ADDENDUM NO. 01

June 2, 2021

RIO SECO –CLASSROOM ADDITIONS

SANTEE SCHOOL DISTRICT

TYP. INTERIOR ELEVATION 4 1/4" = 1'-0" 1

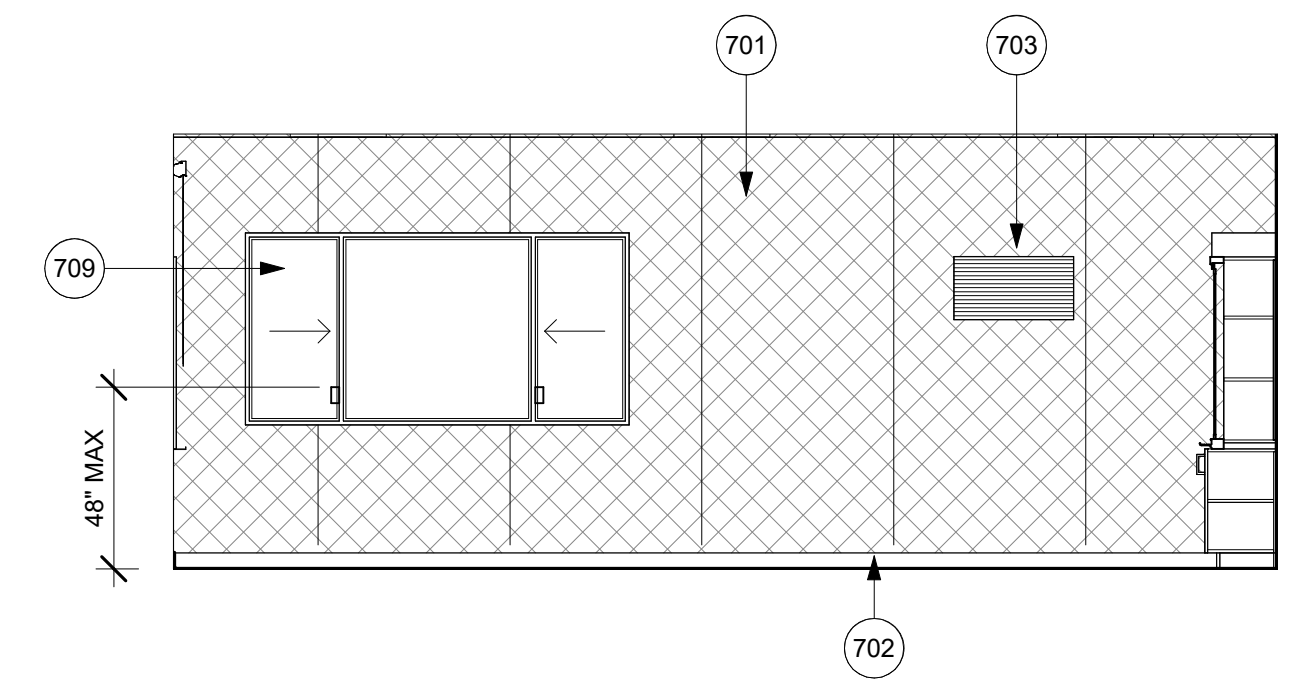
- A. Revise sheet A7.1 Interior Elevations, detail 1 to show new teaching wall casework, per AD1-A7.1.
- B. Revise sheet A7.1 Interior Elevations, detail 3 to add height of projector screen, per AD1-A7.1.

TEACHING WALL SECTION | 1" = 1'-0" | 7

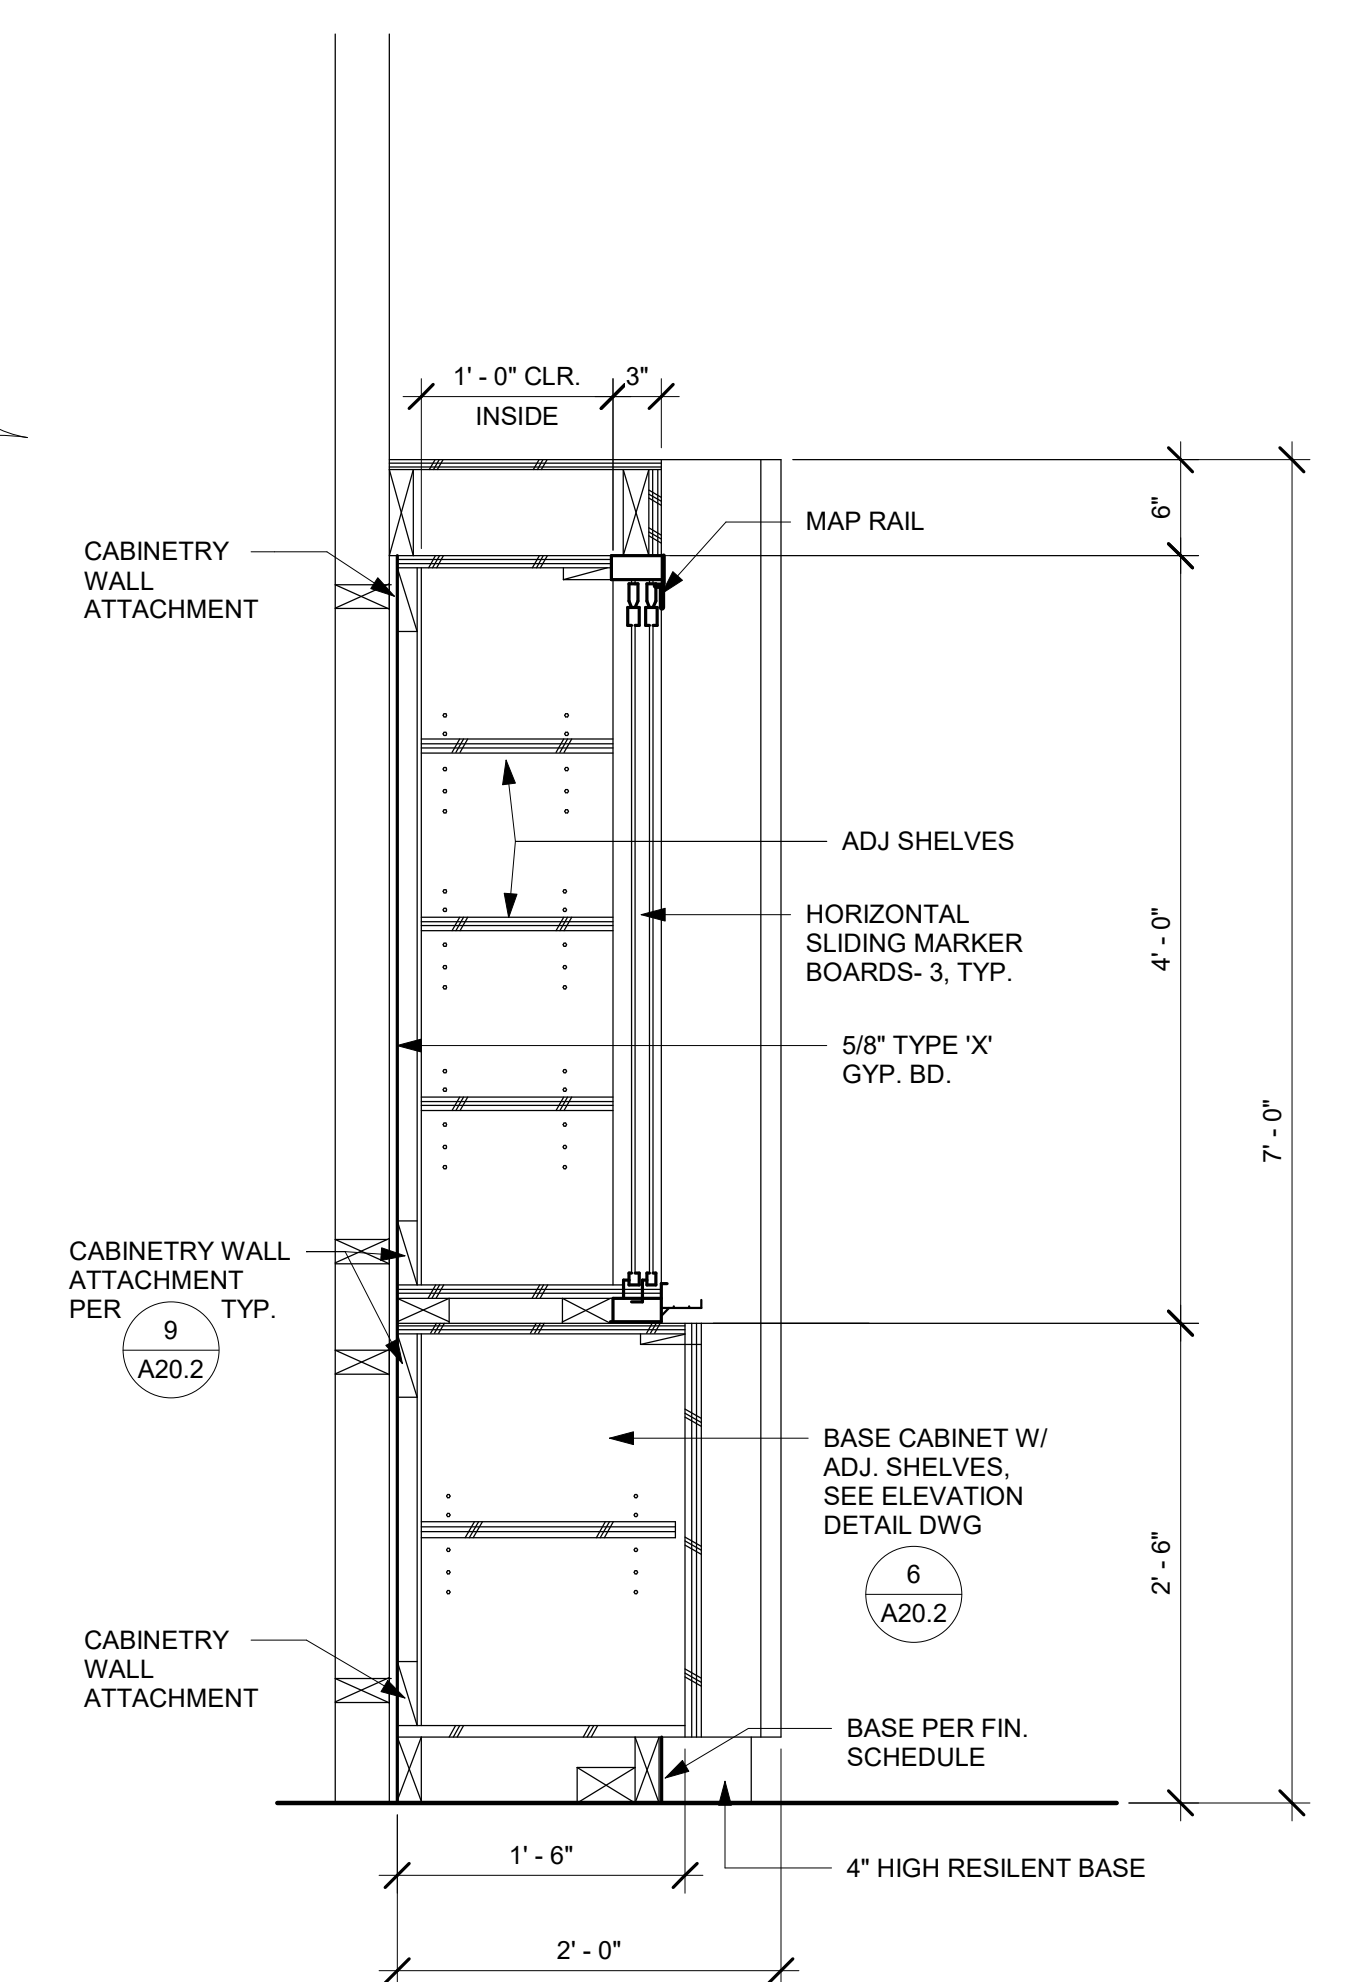
- A. Revise sheet A20.2 Typical Plan Details, to add new details 6, 7 and 9 for Teaching Wall Casework, per AD1-A20.2.
